PUBLIC UTILITIES COMMISSION

EA2025-1245

SUBJECT: Electric Distribution Audit of PG&E's Central Coast Division

PG&E CENTRAL COAST DIVISION
ELECTRIC DISTRIBUTION AUDIT FINDINGS
April 21-25, 2025

Figure 3: Guy slack limit, TD-2305M-JA02

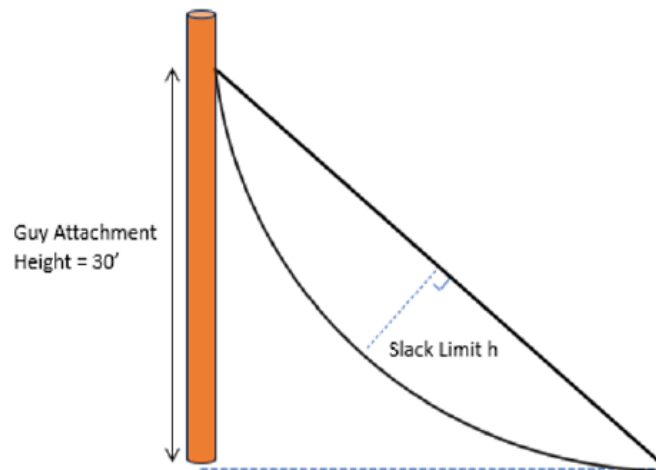
Per GO 95, Rule 56.2, guys are to be maintained taut. PG&E’s TD-2305M-JA02 allows a deviation from taut by as much as 3 feet without regard to length or angle of attachment.

PG&E’s TD-2305M-JA02, Job Aid, Miscellaneous Other Compelling Abnormal Conditions, Guy Broken/Slack/Corroded needs revision to comply with GO 95, Rule 56.2 requiring guys to be maintained taut in all circumstances.
